**LEGAL ADVERTISEMENT
HISTORIC PRESERVATION BOARD
CITY OF PORTLAND
Public comments are taken at all meetings.**

**HISTORIC PRESERVATION BOARD
CITY OF PORTLAND, MAINE**

**PUBLIC HEARING
276 BRACKETT STREET**

RE: June 7, 2017 Public Hearing – Final Review of Proposed
Garage Addition

PARKING AREA

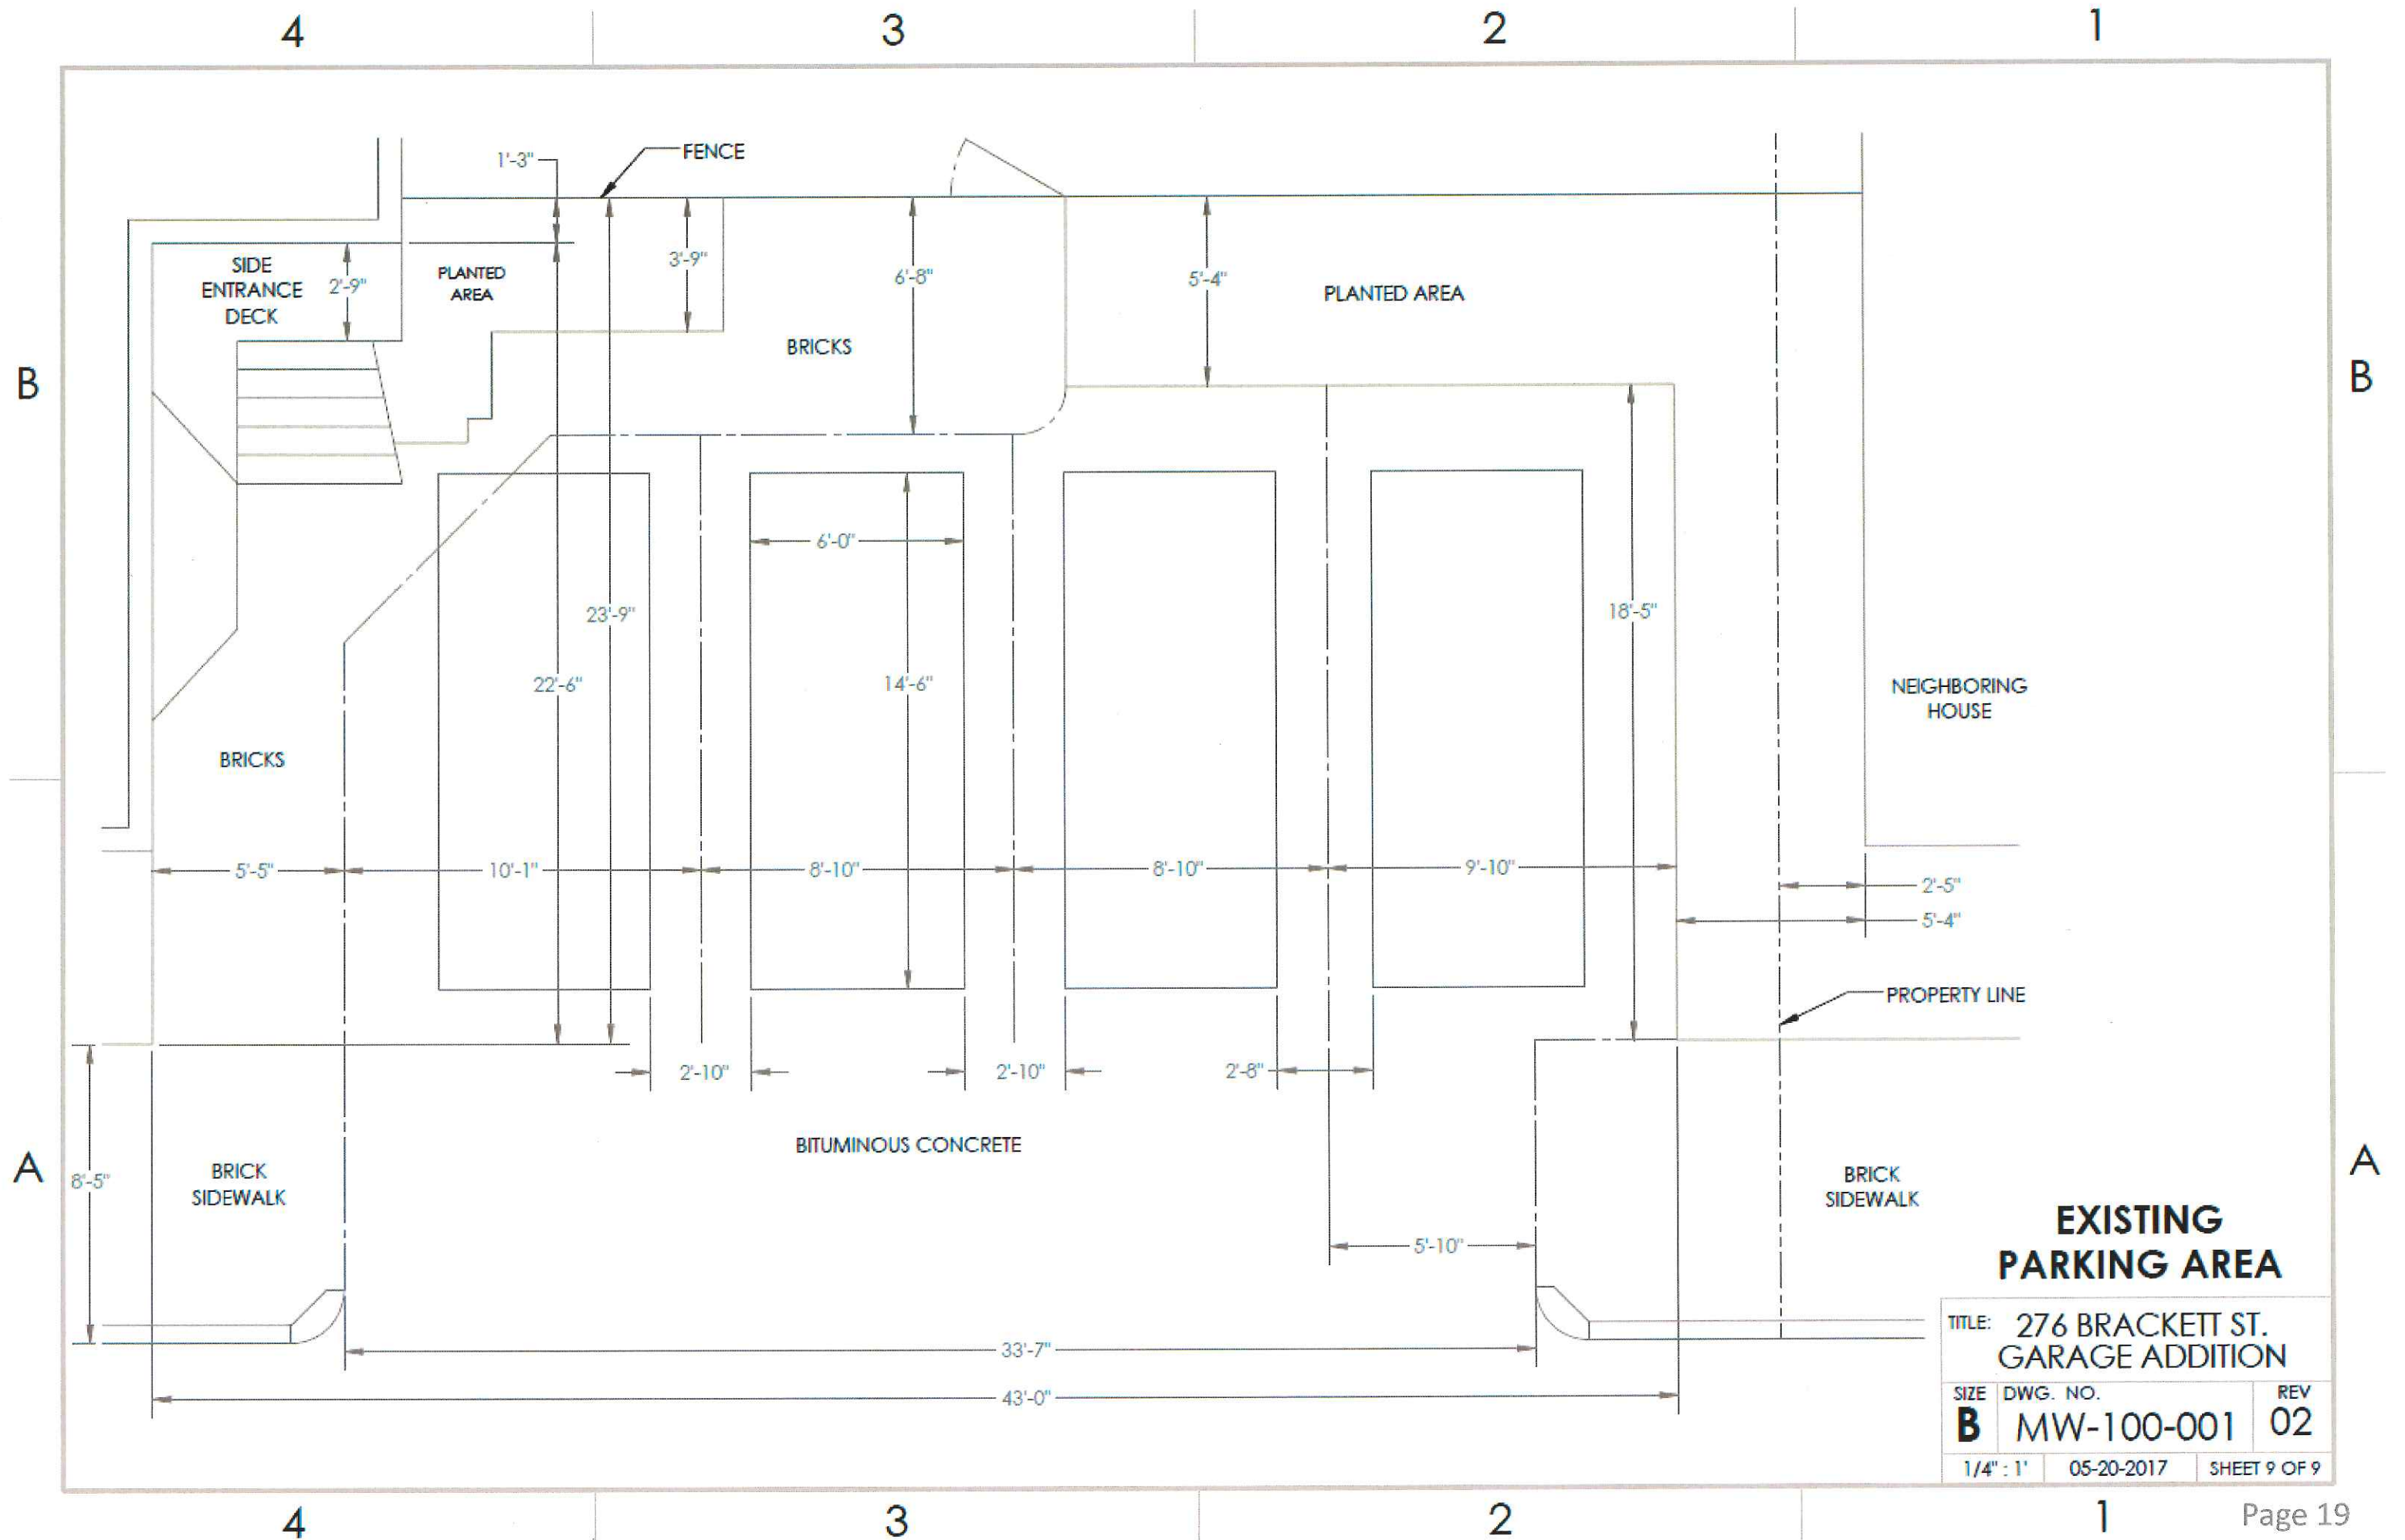
In altering the curb cut and existing parking Mr. Wilson has attempted to address some of the concerns regarding the width, without forfeiting any of the existing spaces. This is perhaps the second threshold question: whether the adjustments made to the site sufficiently change the impact of the parking and curb cut to retain four parking spaces *and* add the garage addition.

- The narrowed area paved with asphalt (approximately 26-1/2' wide,) would not be centered on the curb cut, and would still be wider than, but very roughly centered on,

the garage. A different material – “brick hue concrete pavers” - is proposed for the fourth parking space, lending some modest reinforcement to the relationship between the asphalt and the garage.

- The proposed reduction in the width of the curb cut is a relatively small – 3’-7” – improvement, and the new 30’ width is calculated to be just enough to access all four parking spaces.

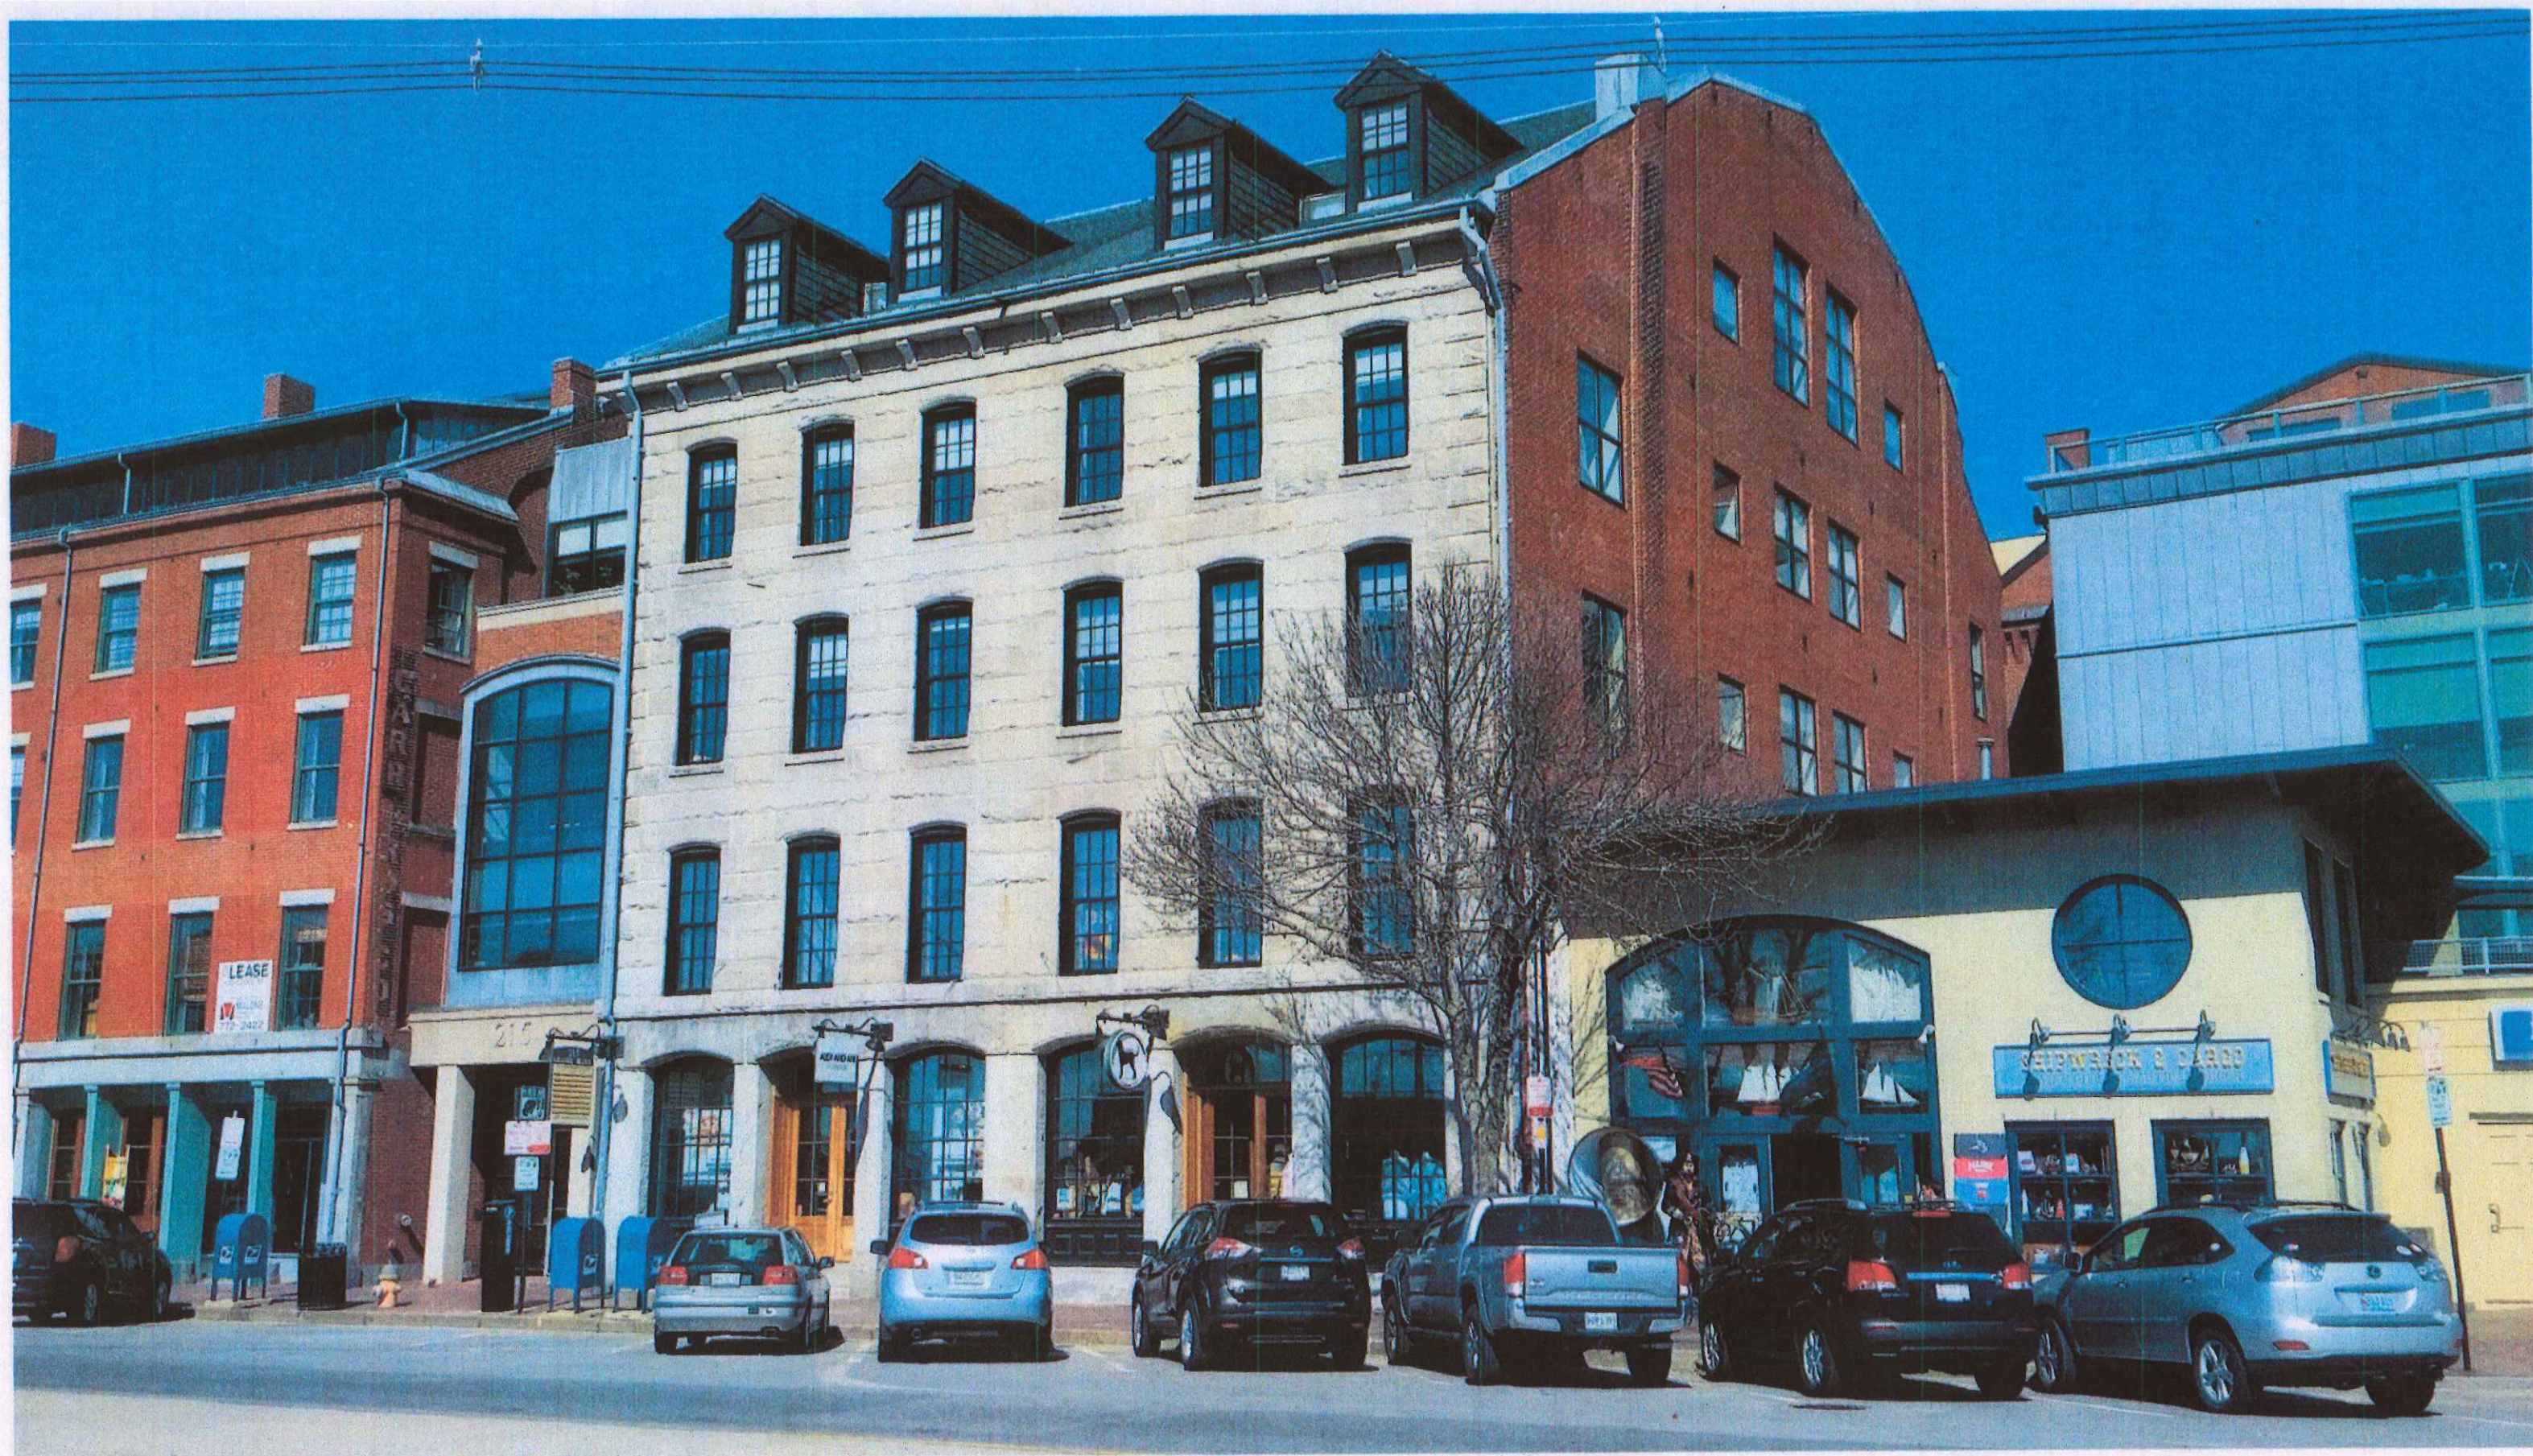
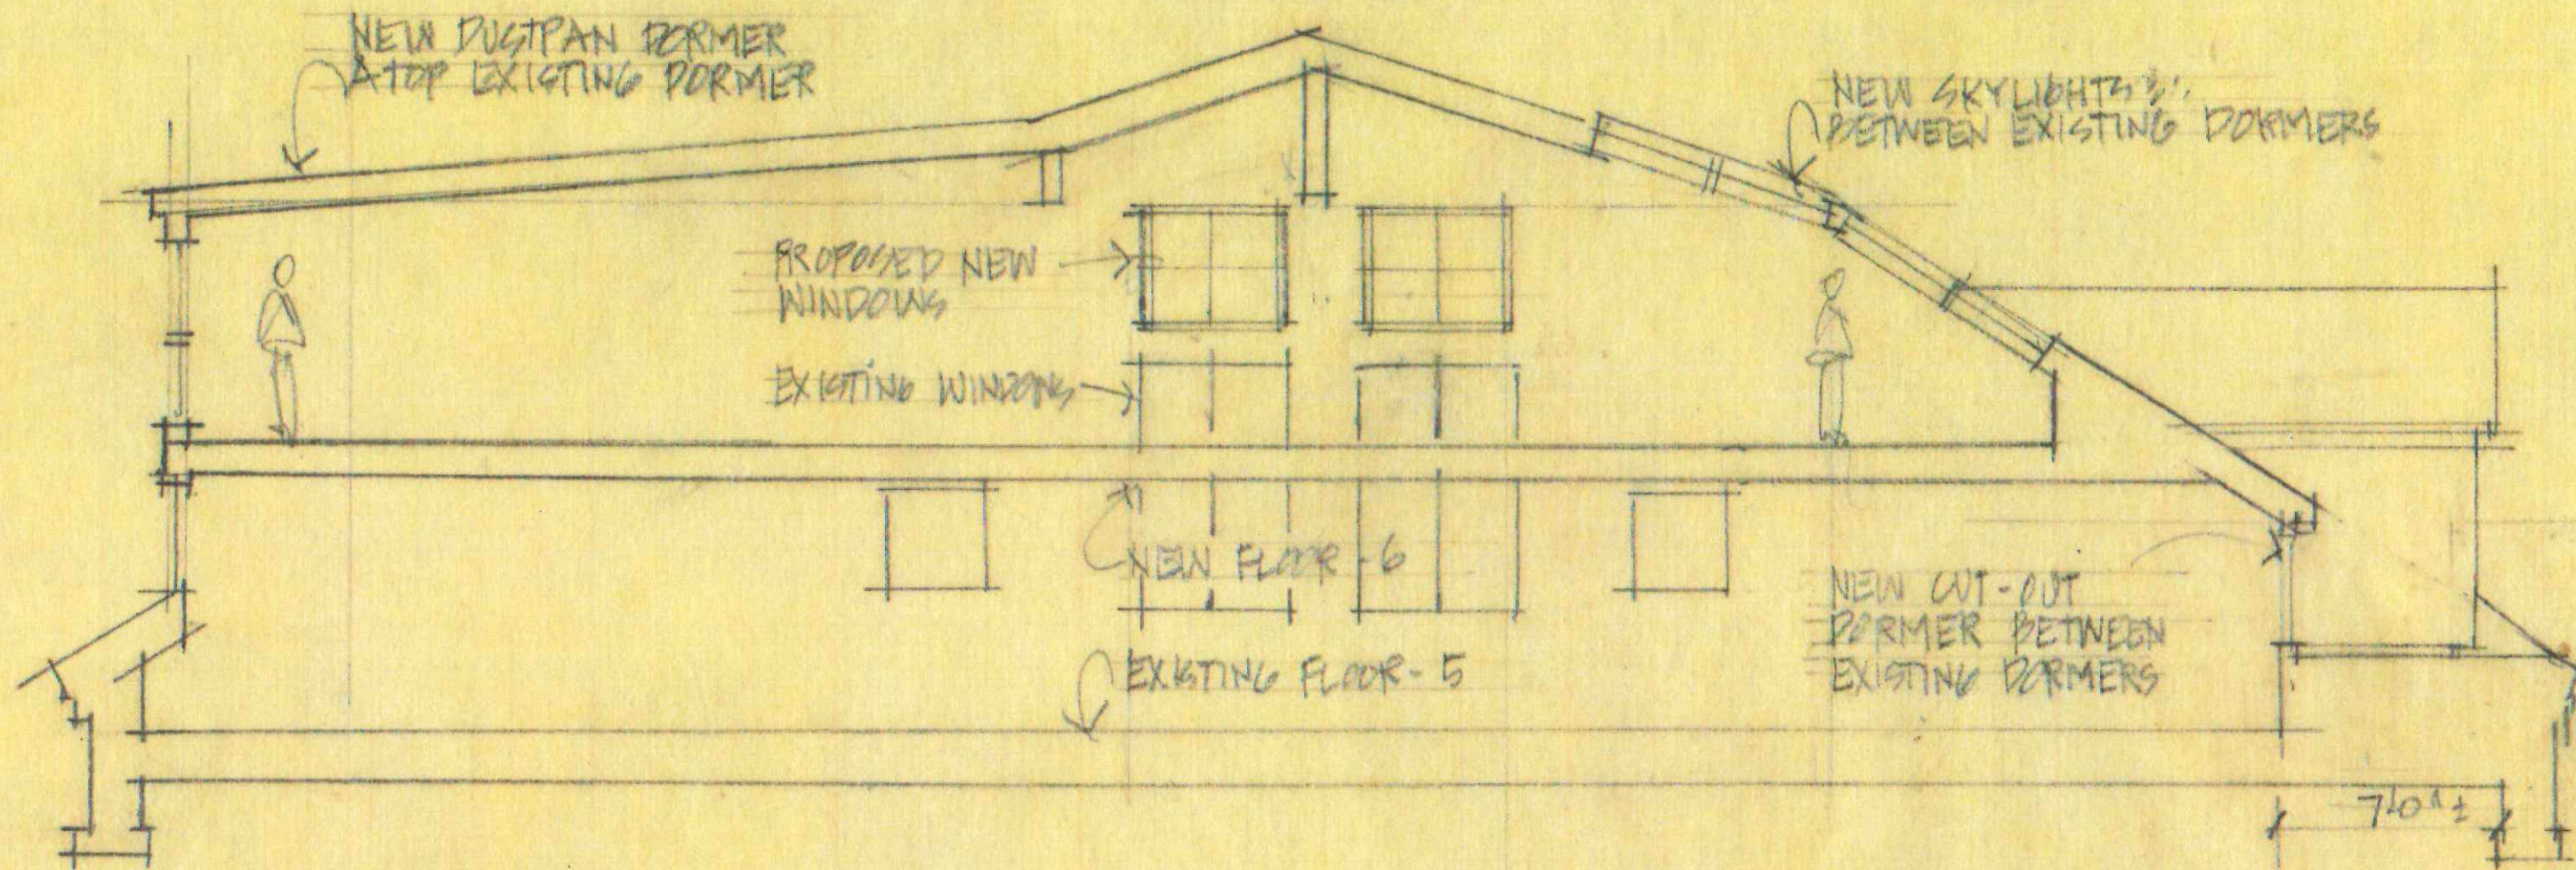
As Mr. Harmon describes in his written summary, Option A is the most like the May 3 proposal, except that there are only two shed-roofed infill walls, one between each of the pairs of dormers. As in the earlier concept, the mocked-up photograph and the description indicate that the shed-roofed infill will be in the same plane as the face of the existing dormers, though Mr. Harmon notes the face of the infill could be set back slightly. It appears that the front elevation of the infill dormers will extend to a height just below the pedimented gables of the existing dormers.

- While staff understands that the dormer solution proposed for the Commercial Street roof plane is intended to preserve the building's doghouse dormers, infilling between the existing dormers creates a hybrid solution that, in staff's view, is visually awkward and calls undue attention to the alterations. Staff is somewhat skeptical that this would still apply to the current Option A, despite omitting the wide infill in the middle of the roof.

- The possibility that the front planes of the two infill walls could be pushed back from the front of the existing dormers would only slightly mitigate the impact of the infill on the pairs of dormers.

Option A shows infill windows connecting either pair of doghouse dormers with a shallow shed roof. The plane of the windows is proposed to align with the existing dormer, or can be set back some nominal distance to create a slight visual break.
